Our Case Number: ABP-314724-22

Re: Railway (Metrolink - Estuary to Charlemont via Dublin Airport) Order [2022]
Metrolink. Estuary through Swords, Dublin Airport, Ballymun, Glasnevin and City Centre to
Charlemont, Co. Dublin

**Written Submission from Dublin City
Council's Chief Executive**

**the National Transport Authority's Application for the Railway (Metrolink-Estuary to
Charlemont via Dublin Airport) Order [2022]**

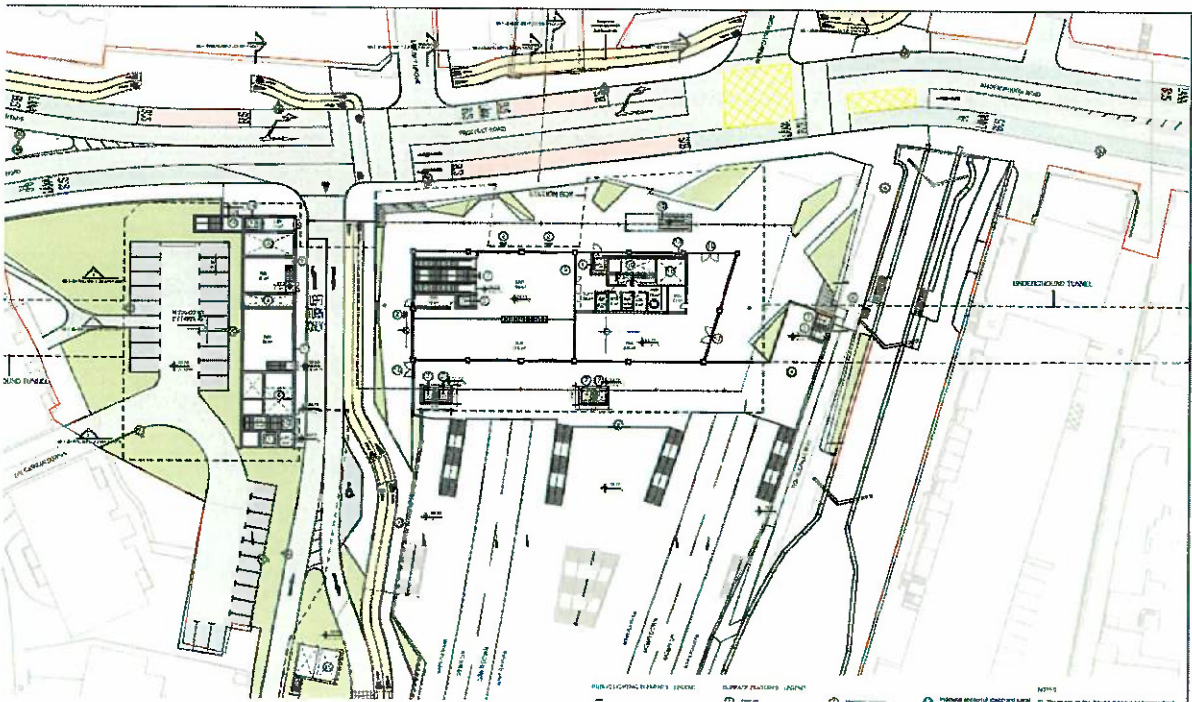
There is a lack of a pedestrian crossing shown to the North of Whitworth Road and the design should be amended to include the third arm at the junction. This will go some way to relieve the congestion at the Whitworth Road crossing and help the pedestrian movement in the area.

The station itself is within a constrained site and this will in time cause some issues, particularly with potential match day/ Croke Park concert traffic. During the detailed design process for this station the consideration of the impact of these one off events needs to be taken into account and the event plans for Croke Park events updated to take account of this new facility. The existing walking provision along Whitworth road is quite inadequate with no footpath provision on one side and separate to this project a specific study of Whitworth road and options for increasing pedestrian space is needed to be undertaken.

Mater Stop

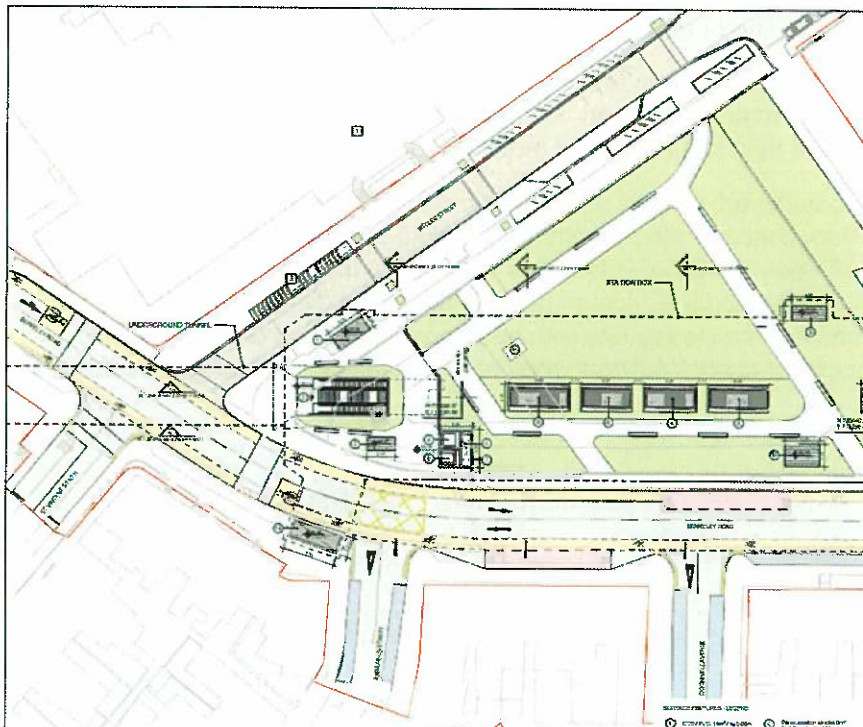
Due to its proximity to the station entrance and associated pedestrian activity, the junction of Berkeley Road, Eccles Street and St Vincent's Road North has been proposed for signalisation however the proposed layout needs to be evaluated in the detailed design phase and the junction tightened up to allow for better and safer operation.

Proposed station layout

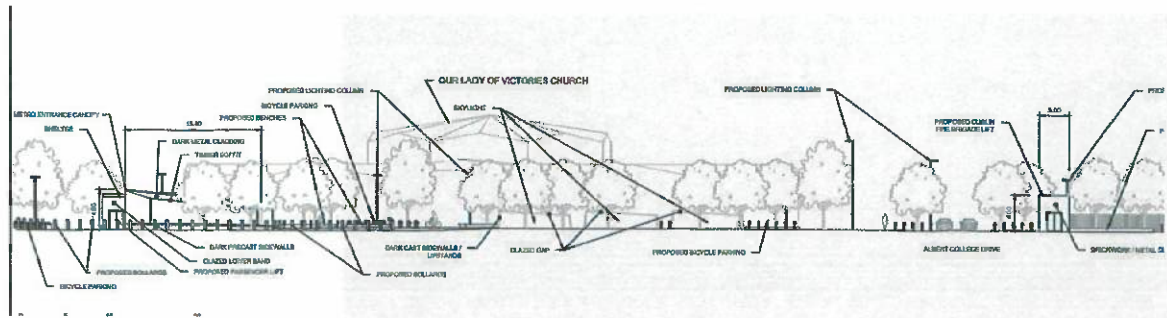
2.1 Ballymun Station: The proposed station lies within the site area of the demolished Ballymun Shopping Centre. Approximately 14 existing trees are to be removed. Impact is considered low and the station development will positively contribute to the urban regeneration area. The station plan indicate there will be more compensatory tree planting and overall it is expected that the proposals will visually improve this location and create a good urban edge to this side of Ballymun Road.

Proposed layout at intervention shaft

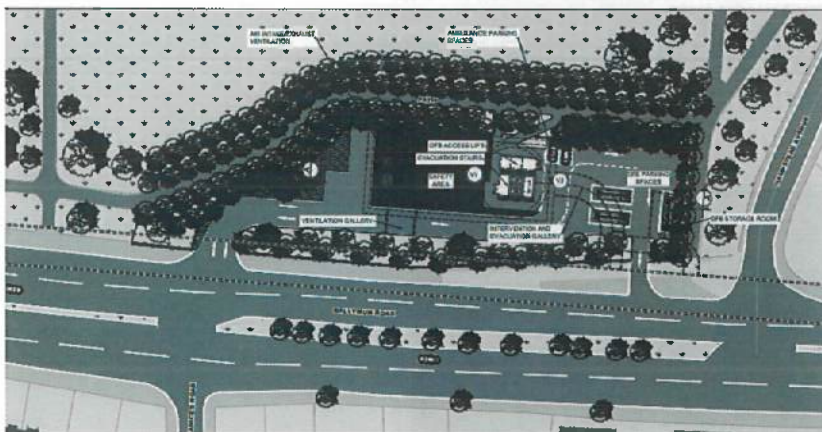
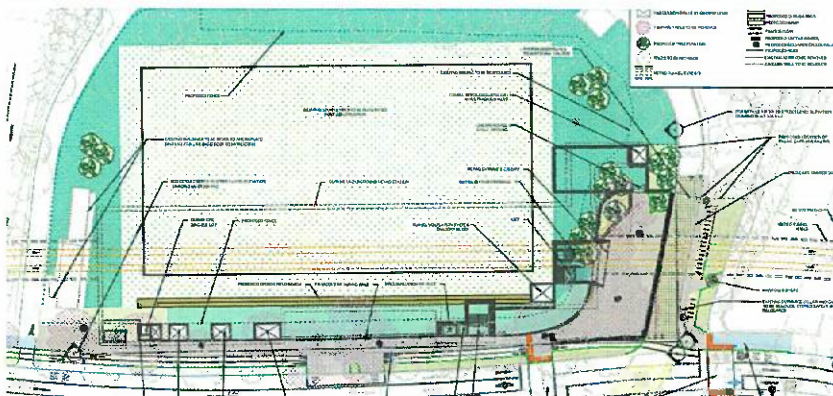
2.3 Albert College Park Intervention Shaft: The proposed facilities will impact on the southwest corner of Albert College Park, as indicated below. The facilities to be constructed include evacuation and ventilation structures with vehicular access and parking. These proposals will impact on the park by removal of a section of the existing mature boundary tree and hedge planting, removal of playing pitch area and perimeter path. The proposals intend to replant compensatory perimeter tree belt and re-route the perimeter park path. The park entrance point is retained and the layout should not impact on the main football pitch. The new facility's boundary on the Ballymun Road should be designed to match the existing park perimeter by use of a hedge boundary with railing to rear if possible.

The following information should be provided to Park Services for approval at detail design stage:

- (a) Site hoarding alignment plan.
- (b) Tree survey, tree impact plan and tree protection plan prepared by an arboriculturist.
- (c) A landscape plan with details indicating the park's landscape reinstatement works, hard and soft works, and boundaries design, prepared by a landscape architect.
- (d) Specification of materials
- (e) Outline project programme, including a 36 month DLP/Maintenance period for all works within the park.

Proposed station layout

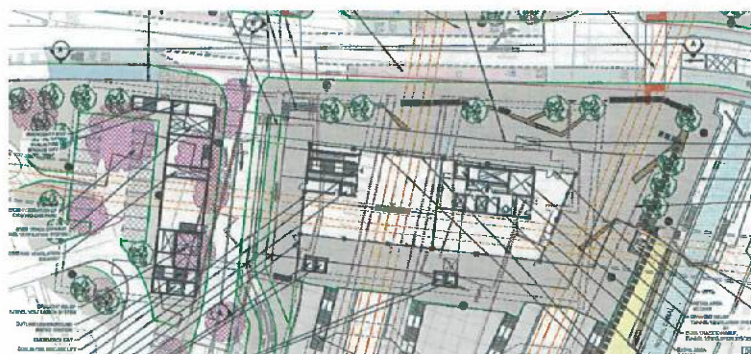
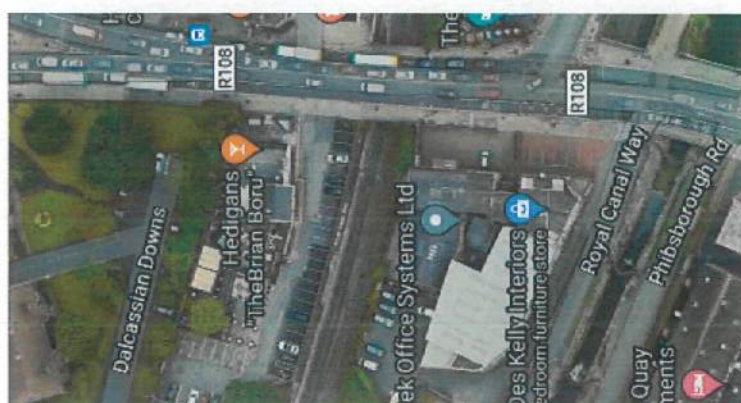
2.5 Glasnevin Station: The proposed station extends from the northern boundary of Dalcassian Downs apartments south over an existing railway cutting to the banks of the Royal Canal. Approximately twenty trees are proposed to be removed, however these would be compensated by a

similar number of new tree planting. The station roof is proposed to include a green roof and a plaza area will front the station on the Prospect Road side with potentially more planting opportunities. Connectivity to the Royal Canal Way and enhancement of greening along the canal boundary are positive elements of the scheme.

Existing park and proposed station layout and public realm upgrade

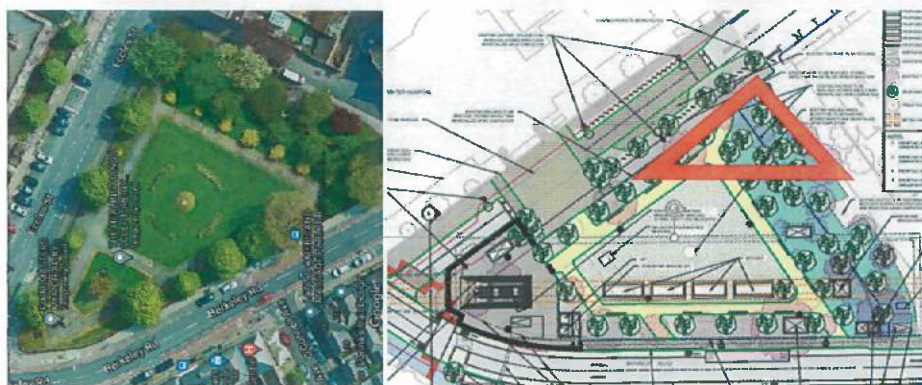
2.6 Mater Station: The station proposals encompass the whole of this small triangular open space that fronts the Mater Hospital and is called the Mater Plot or Four Masters Park. There will be a significant loss of mature and well established trees and consideration should be given to retention within the area highlighted by a red triangle below which may not be affected by the station construction. Following construction the proposals will reinstate the park layout including station access canopies, vents and skylights. Public realm upgrading to Eccles Street fronting the hospitals building's classic portico are also proposed and will help strengthen connection to the park. The station's skylights and vents will visually intrude into the park setting and consideration of vertical greening/ climbing plants to help screen them should be considered. The existing trees should be surveyed before removal so that similar replacement planting may be achieved post construction.

Proposals with street trees potentially removed in purple

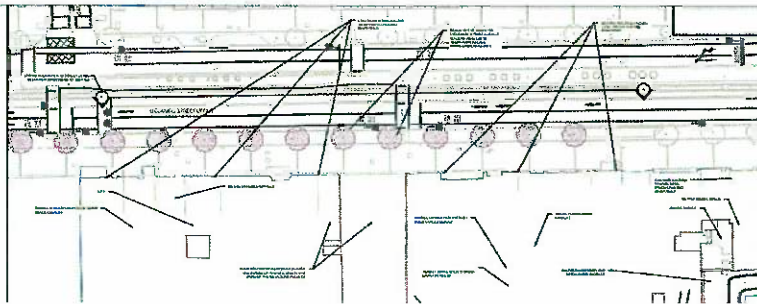
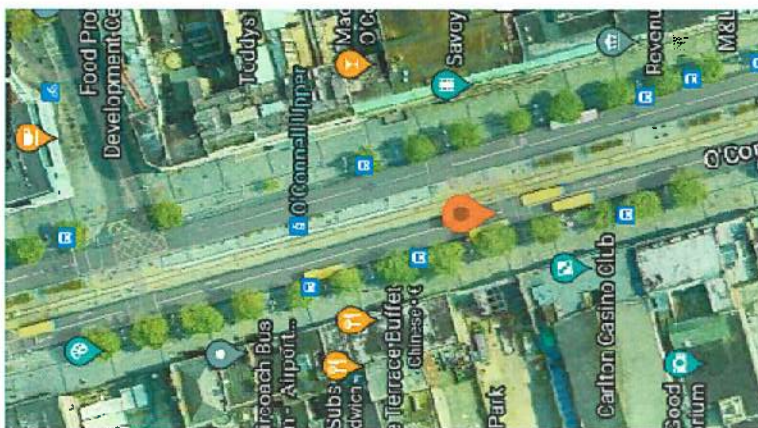
2.7 O'Connell Street: The proposed station development is situated under future building footprints to the west of O'Connell Street Upper. The station drawing below indicates the potential removal of 13 Plane trees 'subject to confirmation of temporary façade protection measures'. The retention of these

trees, which are now successfully established following the street's upgrading works is preferable to Parks Services. Further discussions are required should their removal be considered essential as future compensatory planting post development will require careful planning to maximise the success of re-planting and establishing the tree row.

Existing location and proposed station layout at Tara Street

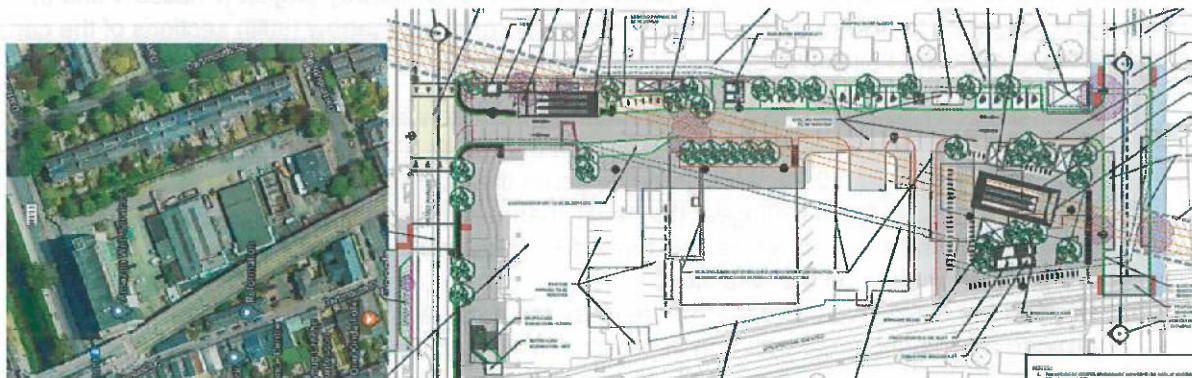
2.8 Tara Station: the proposed station and plaza lies adjacent to the existing Tara Street railway station. There are no landscape impacts arising from the development and generally a positive upgrade of the local public realm will occur. Further greening opportunities could be considered for the site with additional street tree planting and green roofs to any proposed buildings. A more detailed landscape /public realm plan should be prepared.
